GULF STATES UTILITIES COMPANY

River Bend Station - Unit 1
Docket No. 50-458

ATTACHMENT
GULF STATES UTILITIES COMPANY
RIVER BEND STATION
DOCKET 50-458/LICENSE NO. NPF-47

REFUELING AND FUEL HANDLING PLATFORMS

FIGURE 1
 PROPOSED WATER COVERAGE LIMITS
 (CONTAINMENT FUEL POOLS)

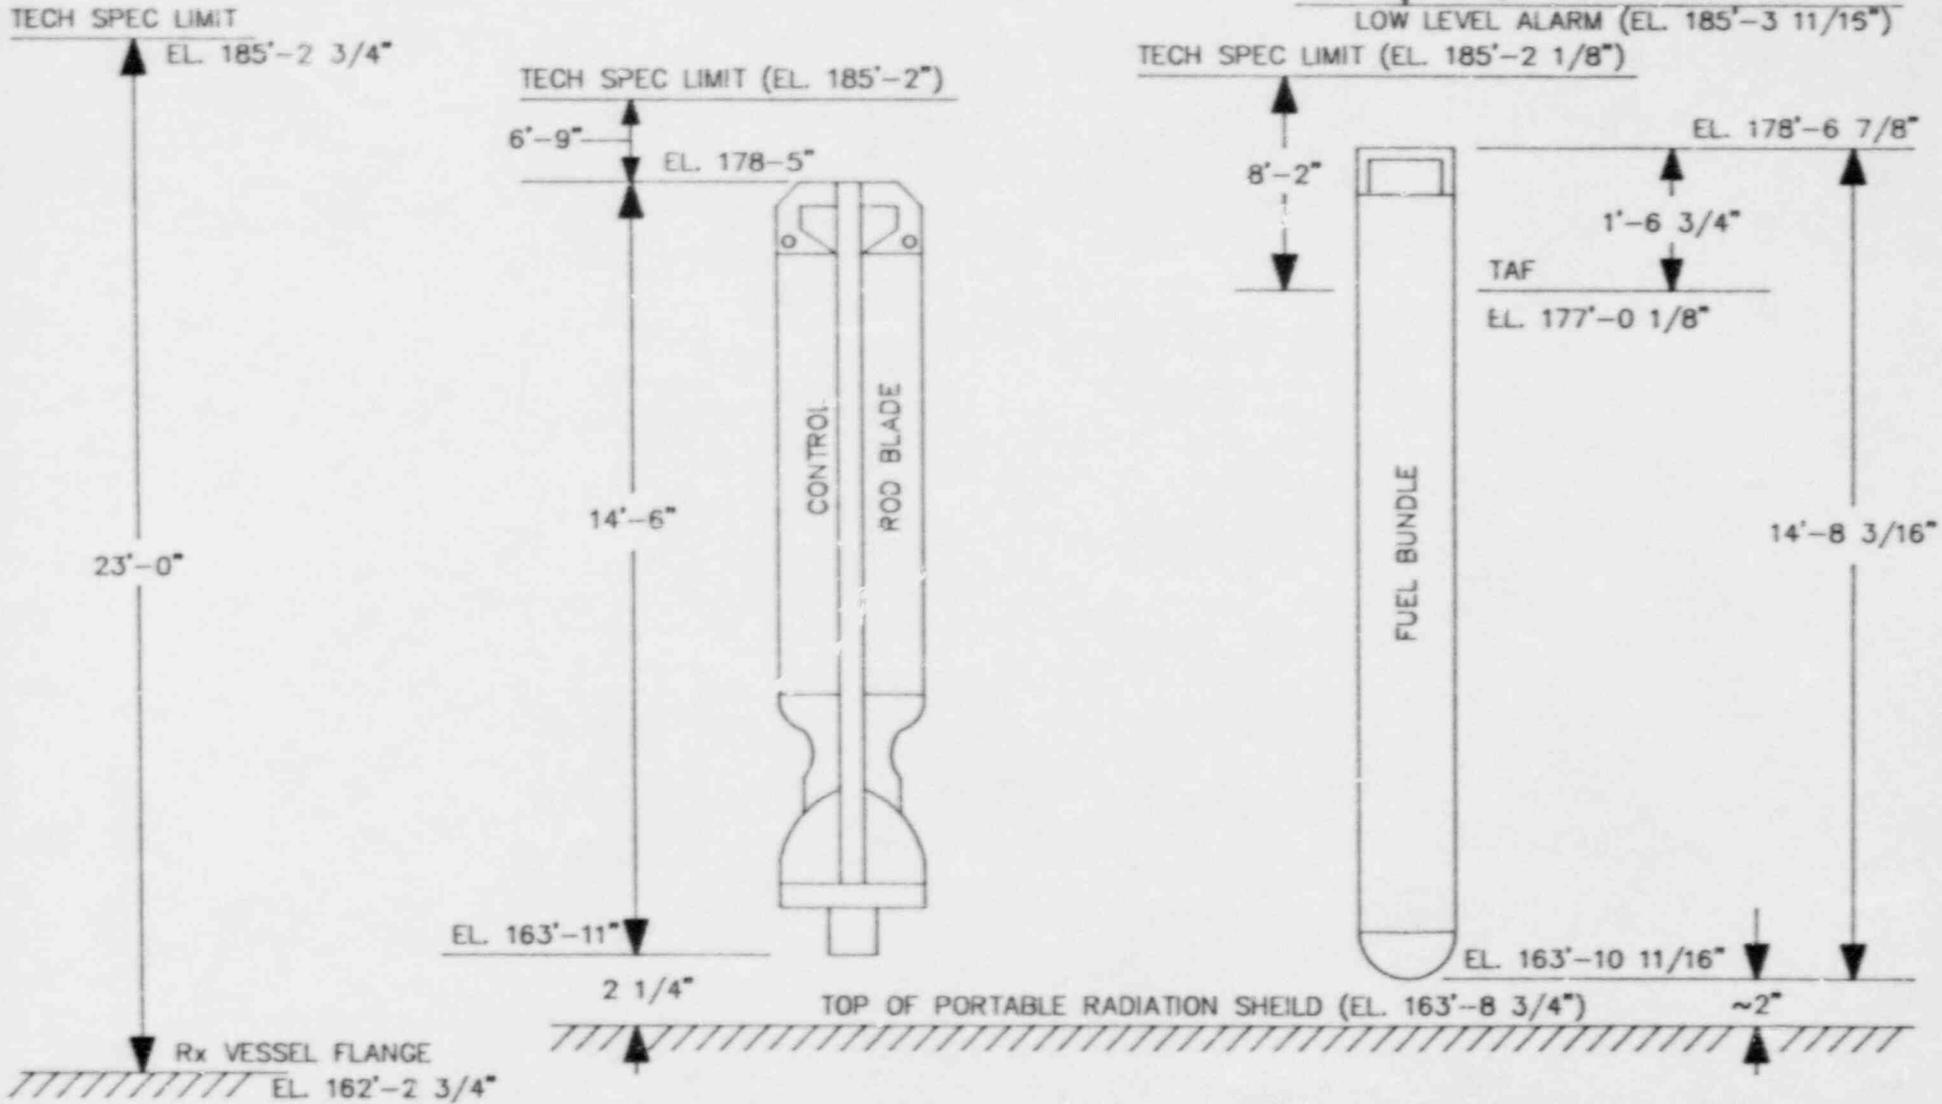
For these reasons, it is being requested that the minimum required water coverage over the top of active irradiated fuel be reduced from 8 feet 6 inches to 8 feet 2 inches, and the minimum required water coverage over irradiated control rods be reduced from 8 feet 6 inches to 6 feet 9 inches (see Figure 1).

FIGURE 2
 PROPOSED WATER COVERAGE LIMITS
 (FUEL BUILDING POOLS)

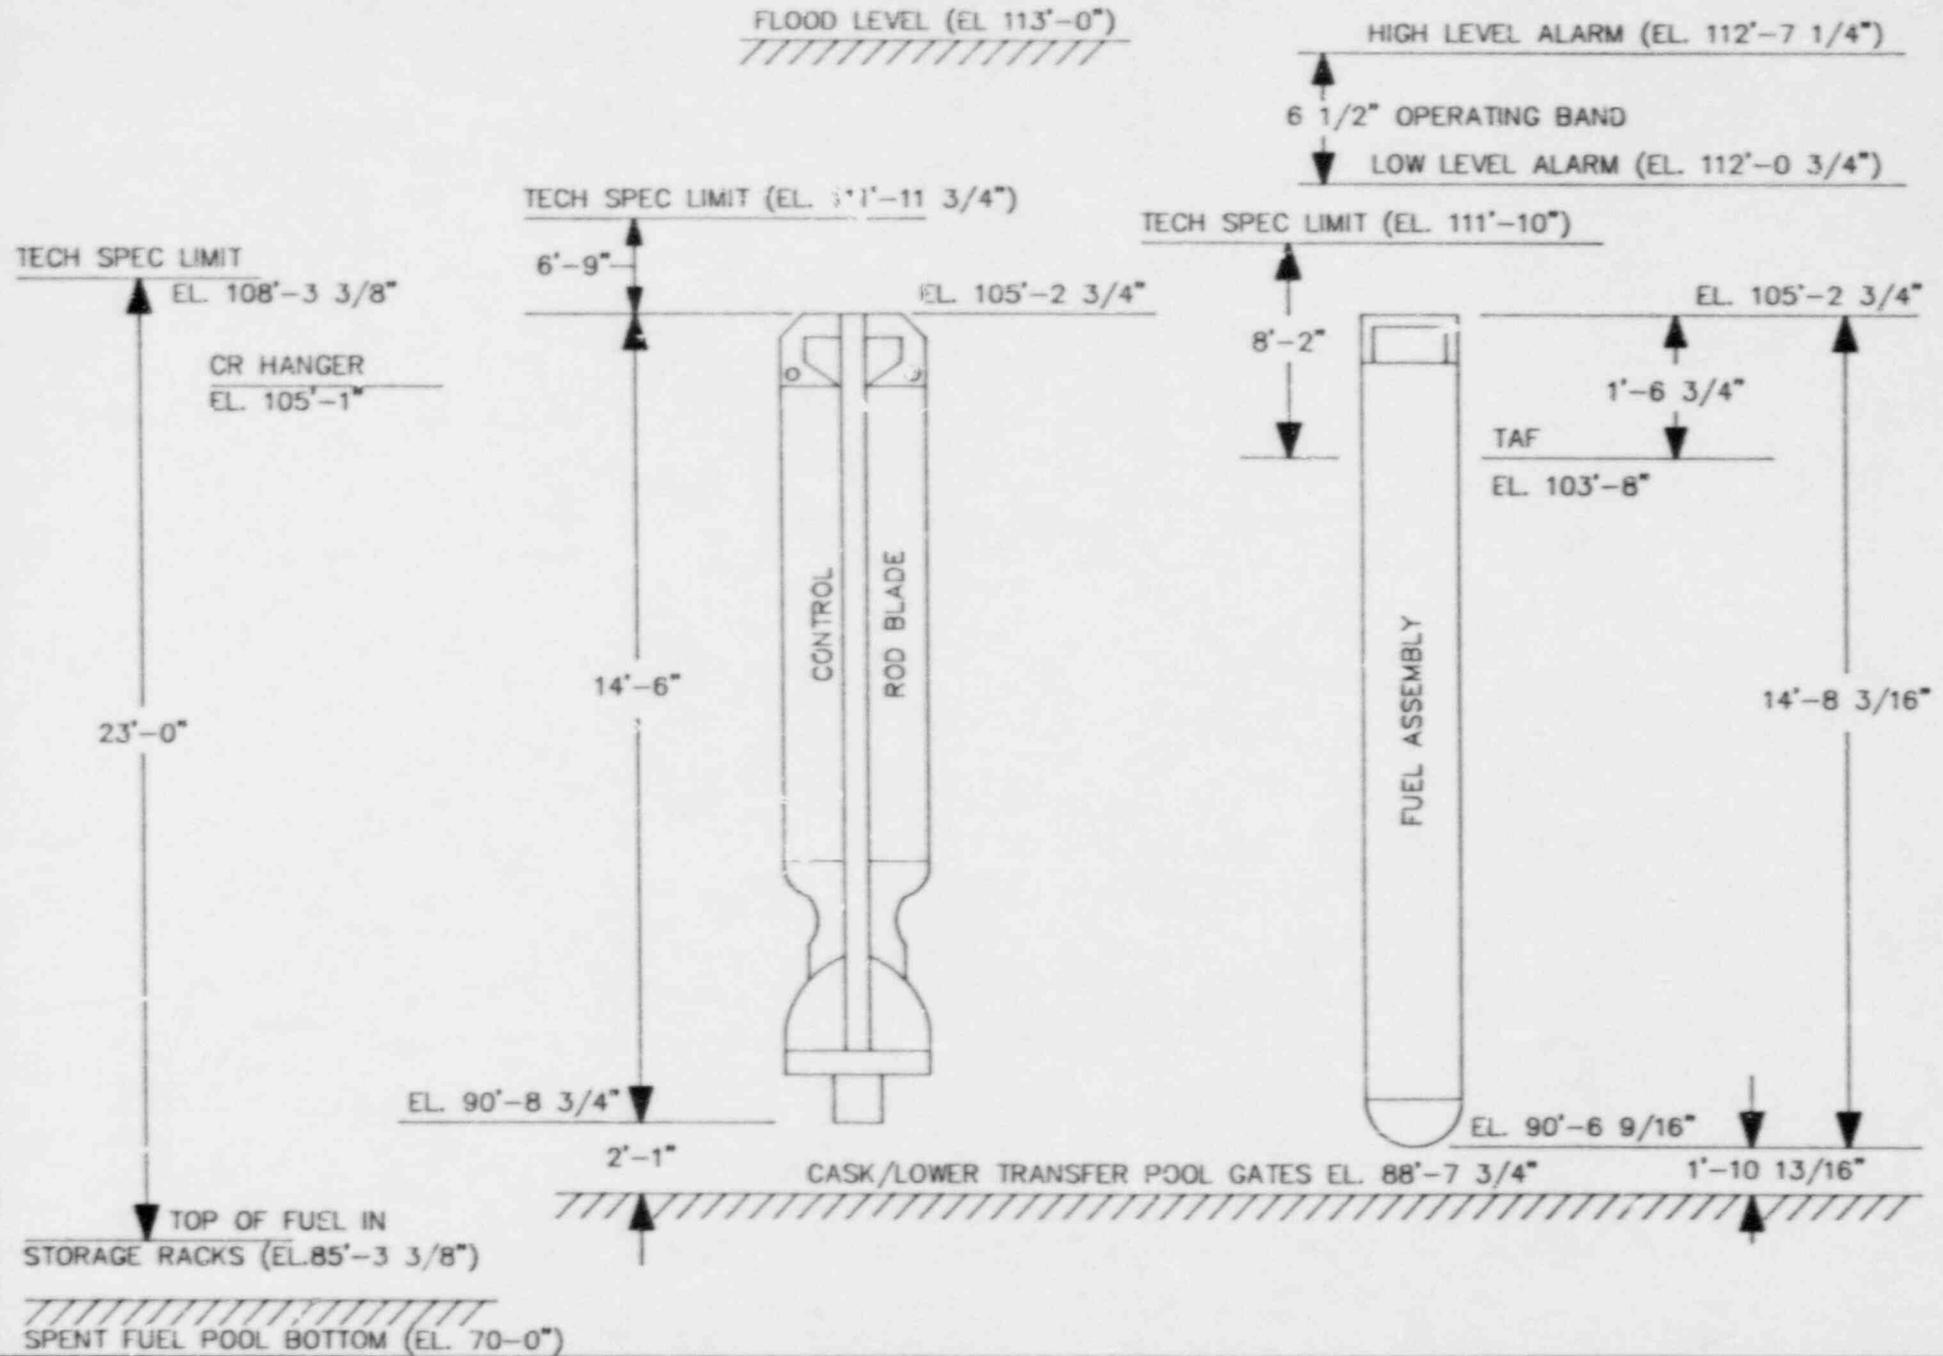
It is also being requested that Surveillance Requirement 4.9.6.2, "Fuel Handling Platform", be revised in a congruent manner (see Figure 2) to permit placement of the control rods on hangers provided in the spent fuel storage pool in the fuel building, and to maintain consistency (i.e., the same minimum water coverages as specified for the refueling platform) in the RBS Technical Specifications.
